## Arklow Flood Relief Scheme

Response to Submissions relating to  
Planning & Environmental Matters  
(ABP ref 301368-21 & 310377-21)

D5246

Issue | 12 January 2022

LANDSCAPE DESIGN AND PUBLIC REALM  
1:500

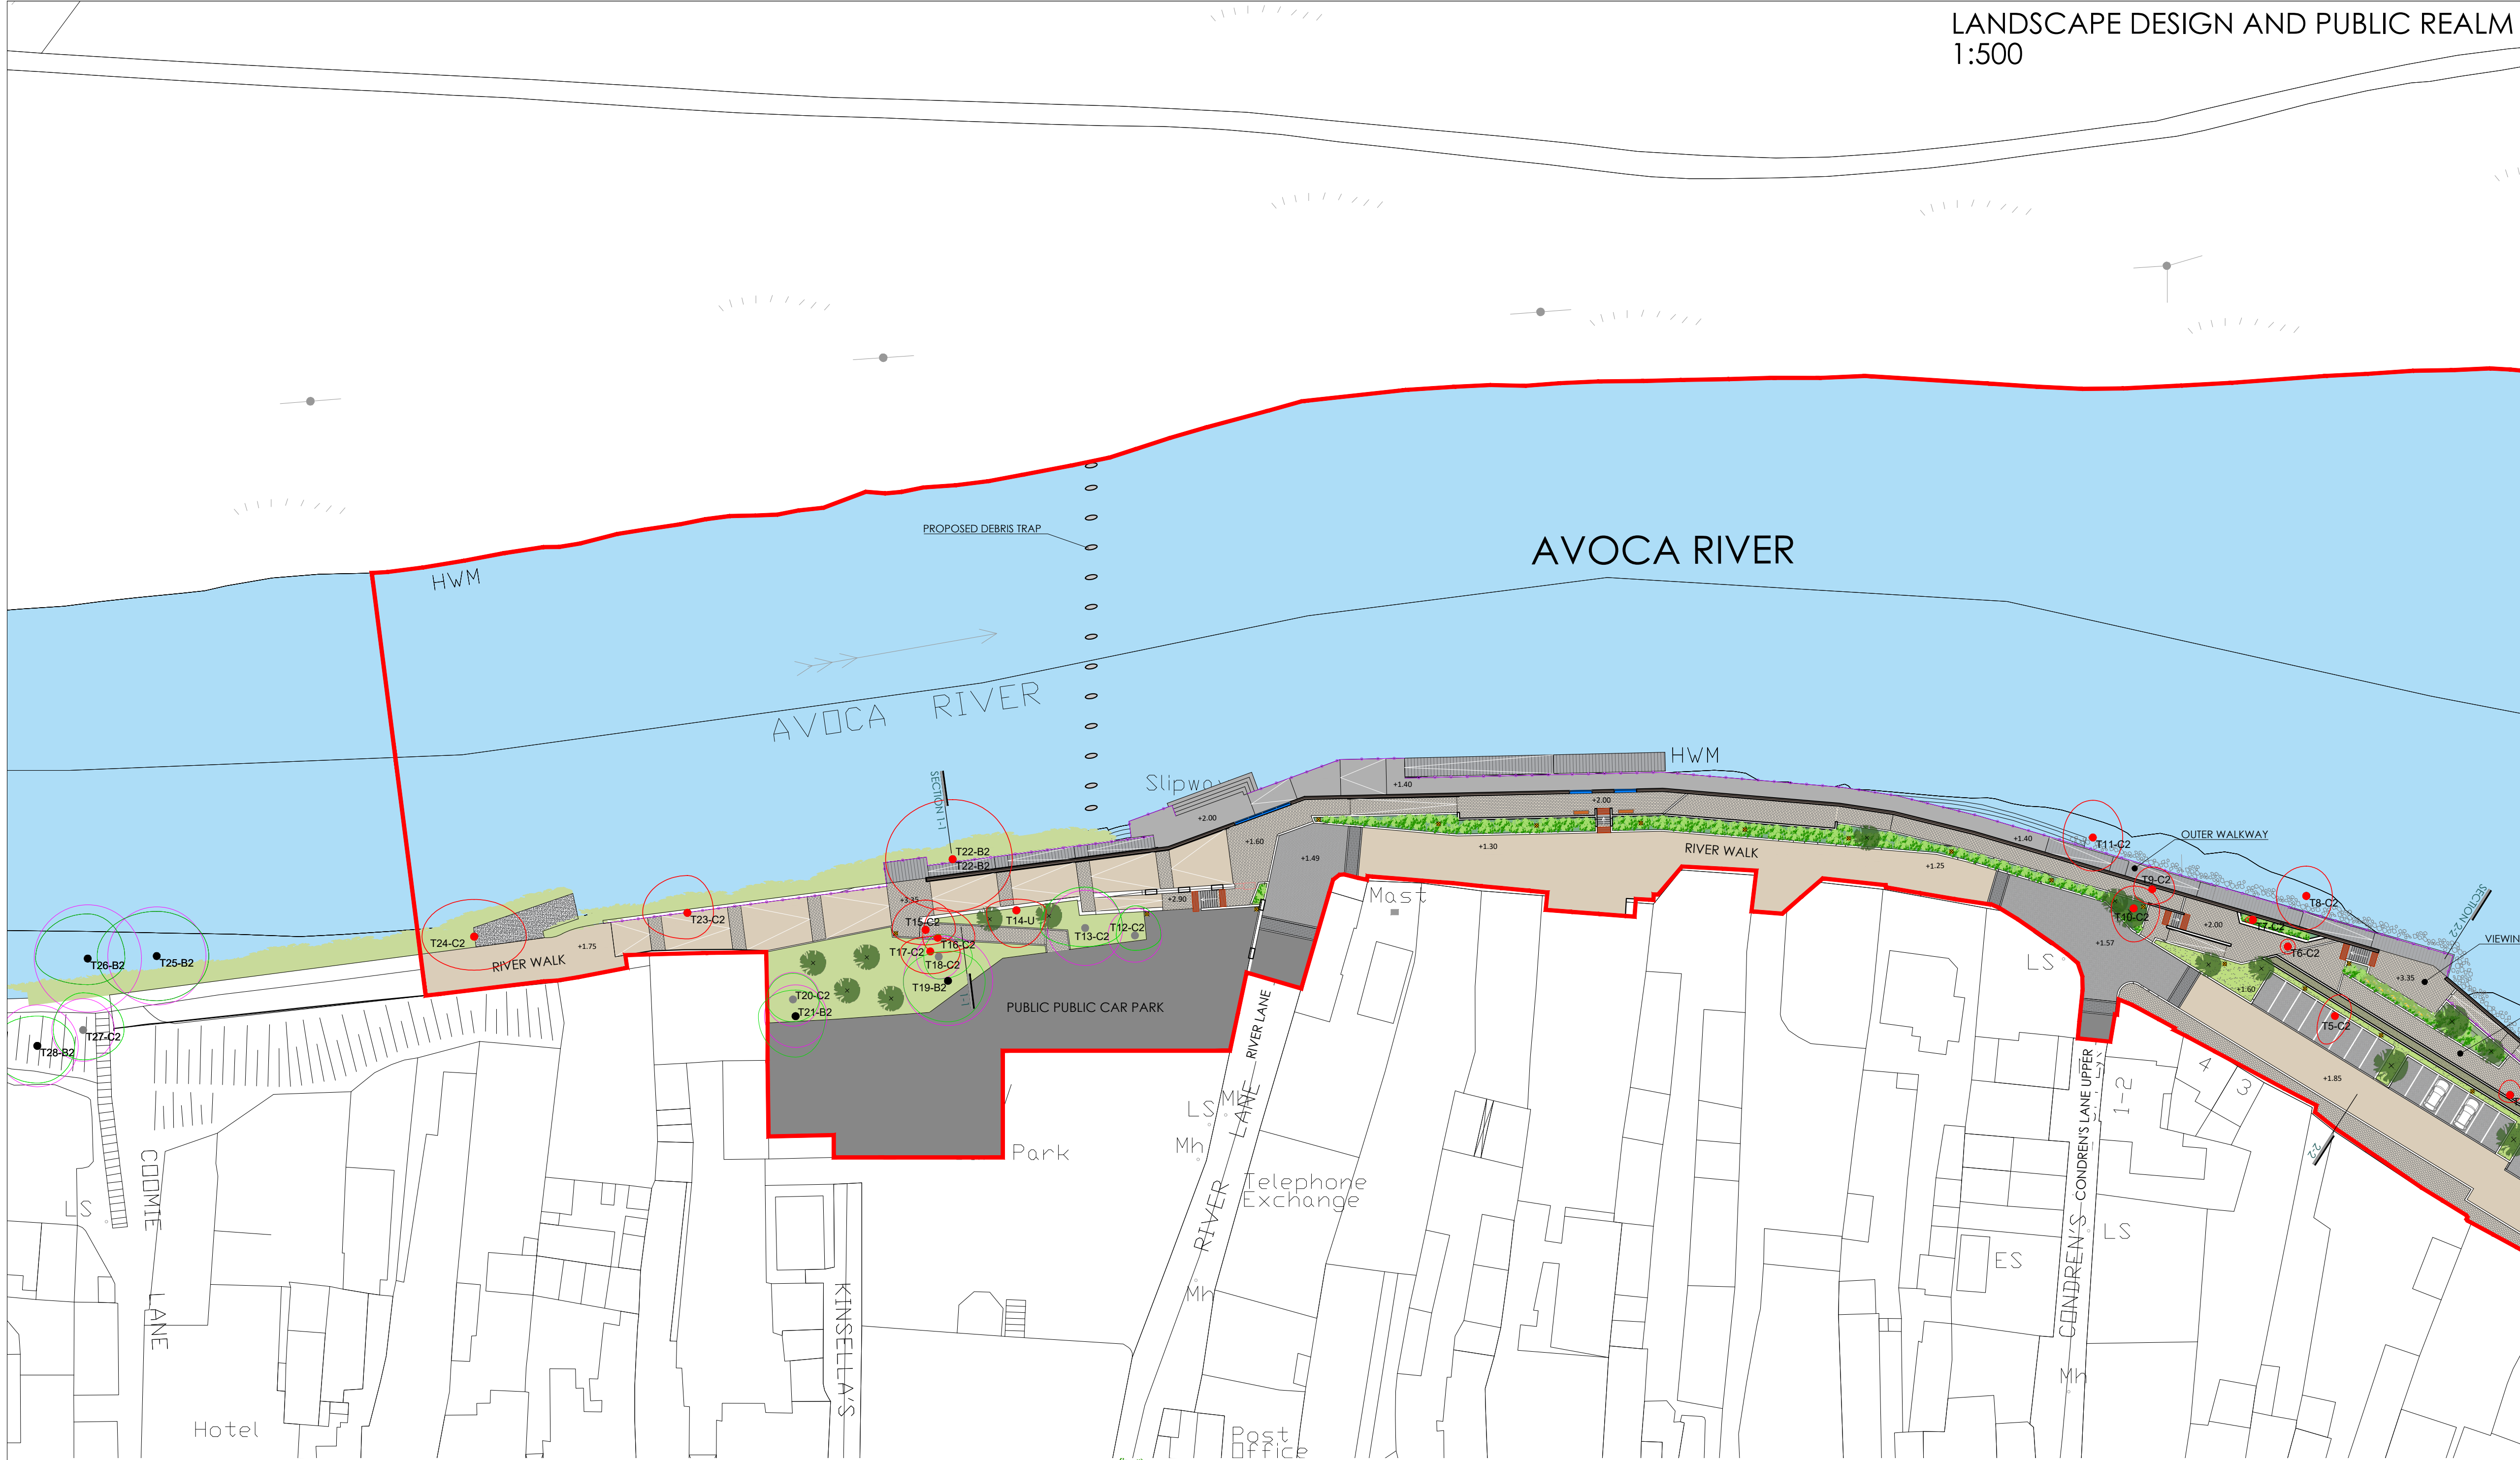
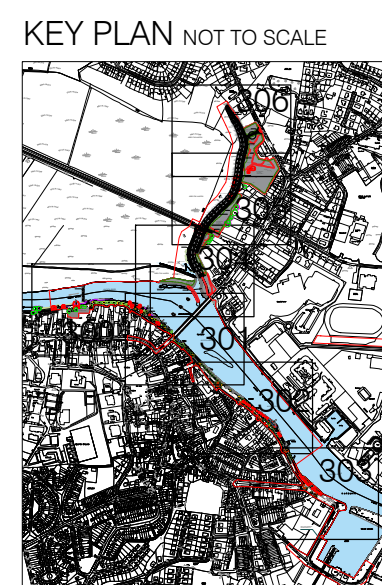
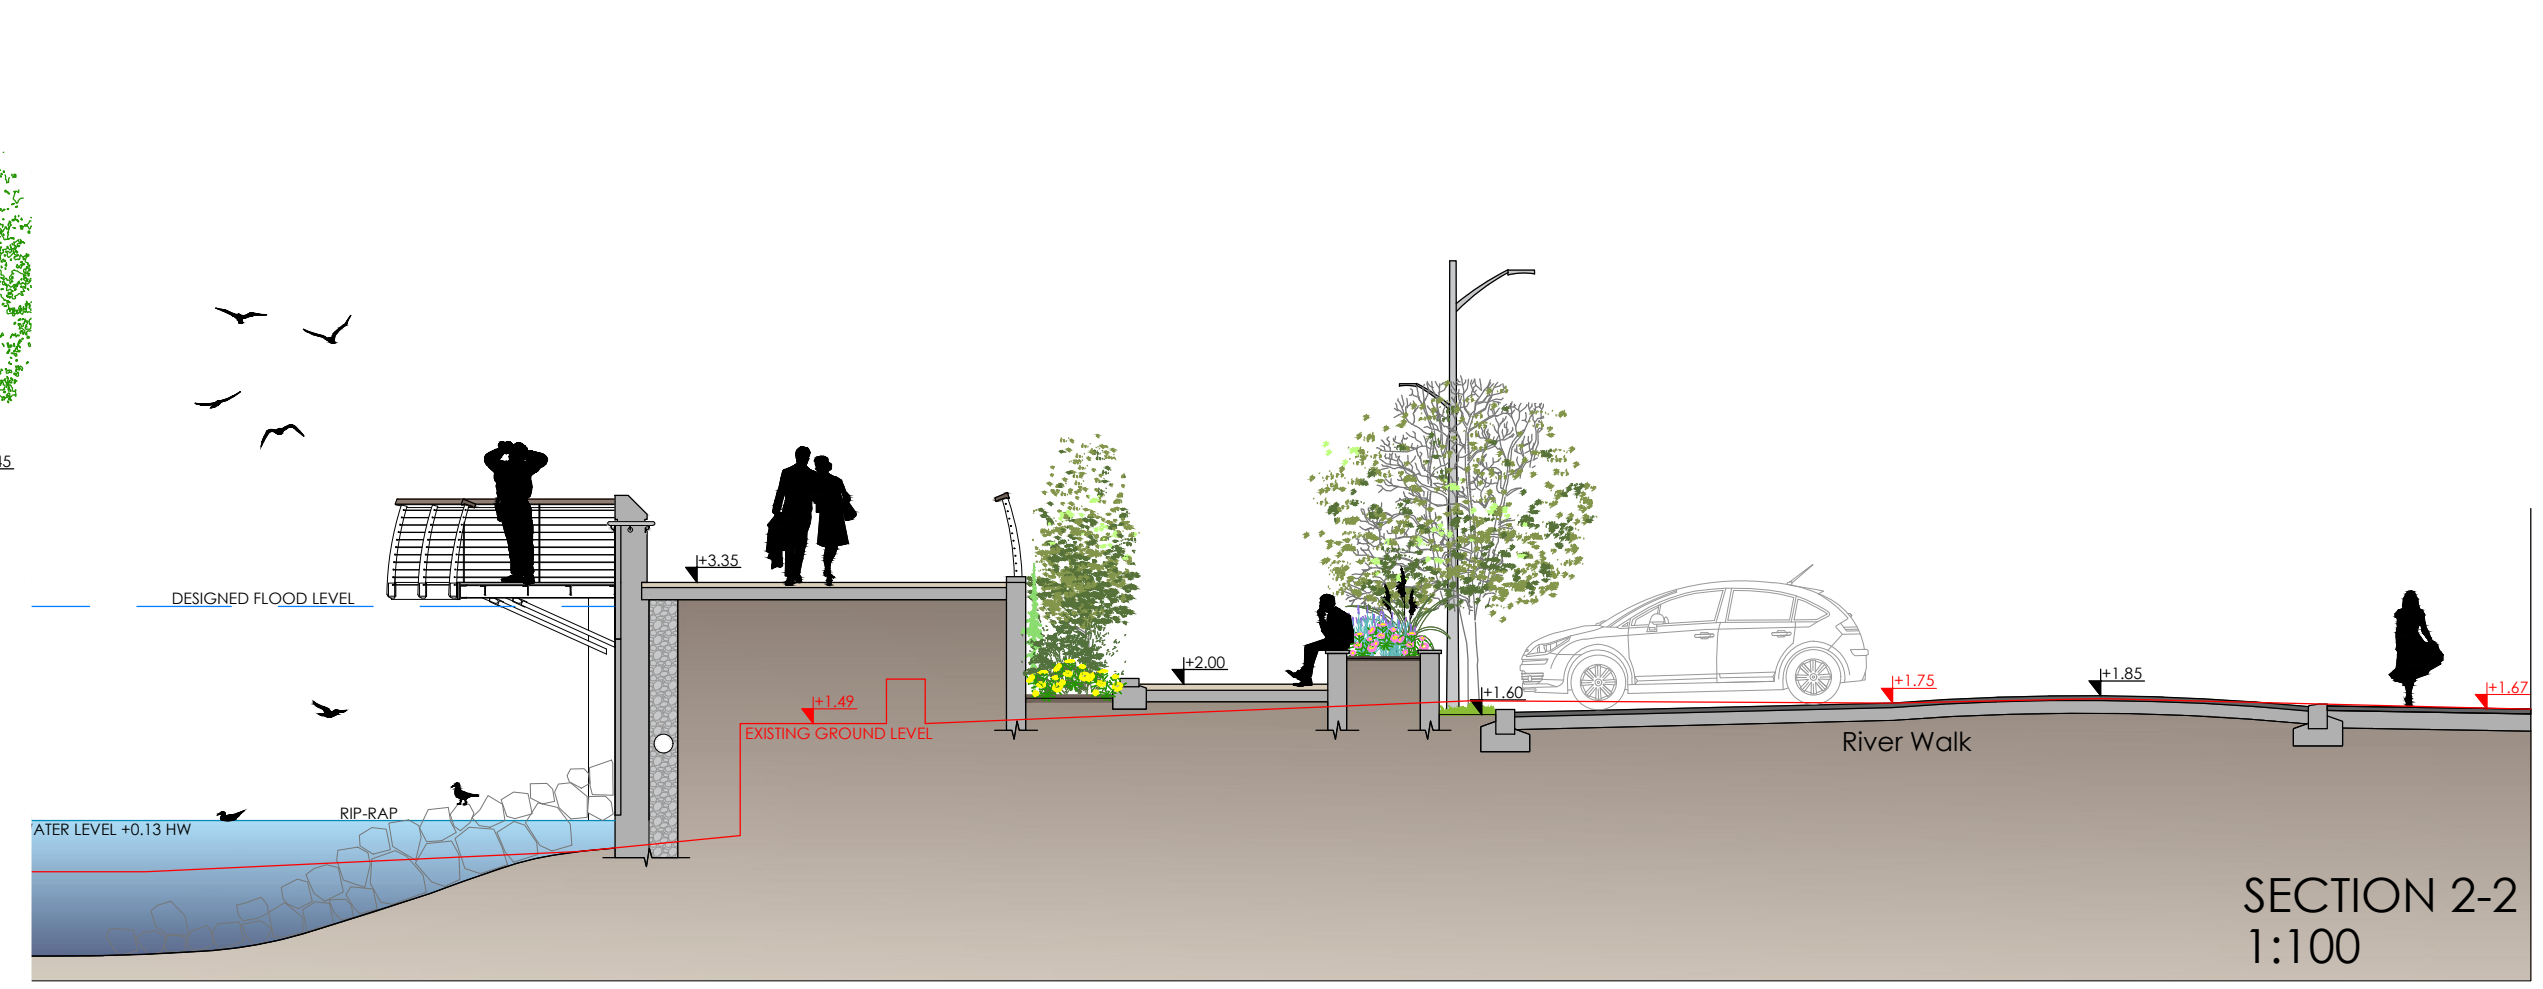
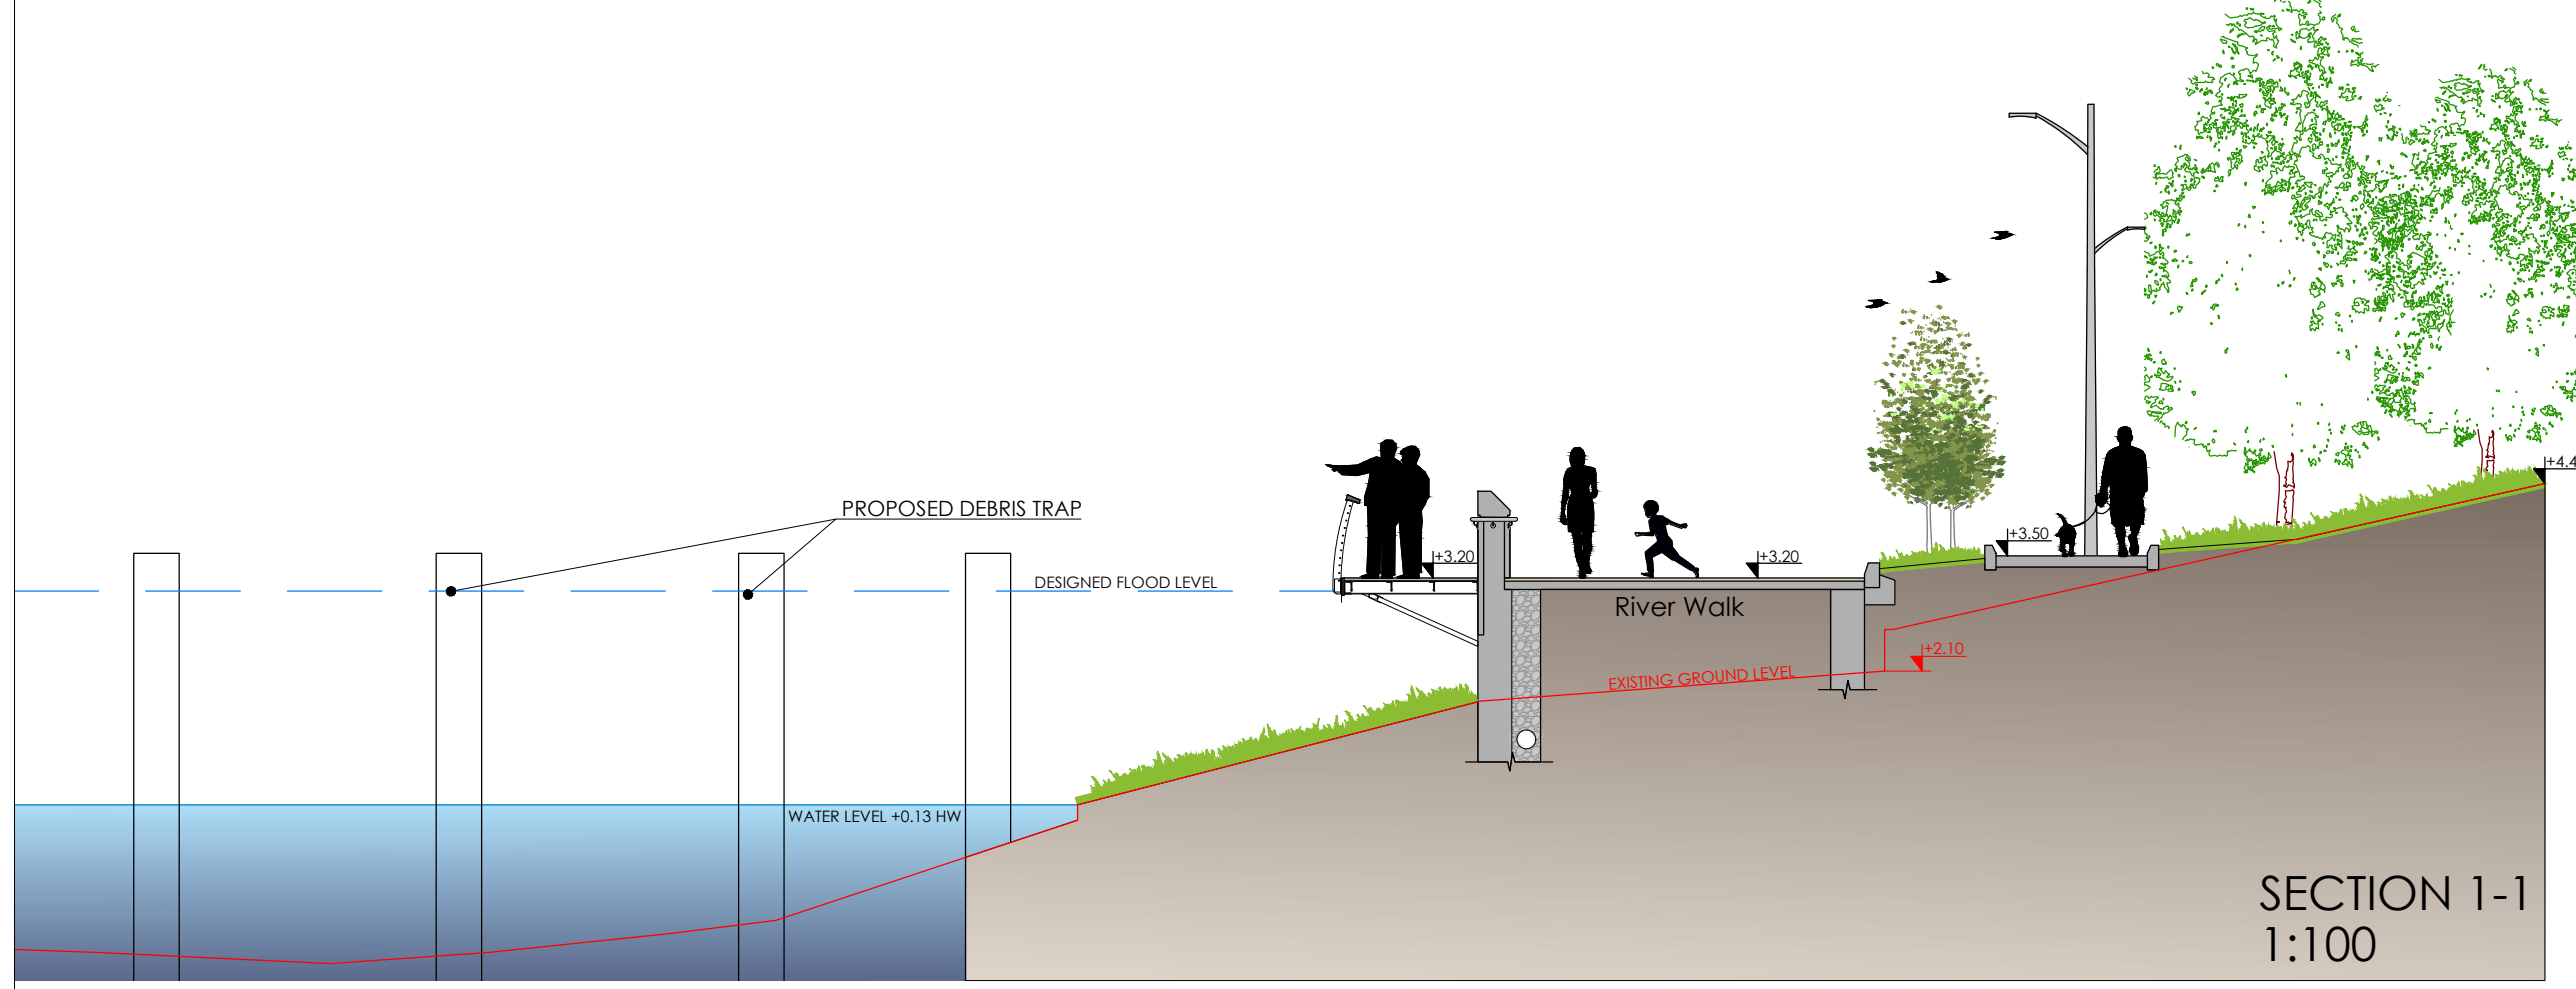
In response to the submissions/objections received by ABP, it is now proposed to include an additional 30.0m of glazing at the following locations listed below. Drawing Nos 1036-1042 and 1046 of Appendix 4.1 (*Scheme Drawings*) and Drawing Nos 301-302 of Appendix 4.2 (*Landscape Design and Public Realm Drawings*) of the EIAR have been revised to reflect these changes and are included in **Appendix A** of this report.

- Addition of two 6.0m long glass panels just downstream of Arklow Bridge on South Quay at approximately Ch 020 (12.0m total), as shown on revised Scheme Drawing No 1040 and revised Landscape Design and Public Realm Drawing No 301 in **Appendix A** of this report. This will open up views of the bridge downstream.
- Addition of three 6.0m long glass panels along South Quay at approximately Chainage 370 (18.0m total), as shown on revised Scheme Drawing No 1041 and revised Landscape Design and Public Realm Drawing No 302 in **Appendix A** of this report.
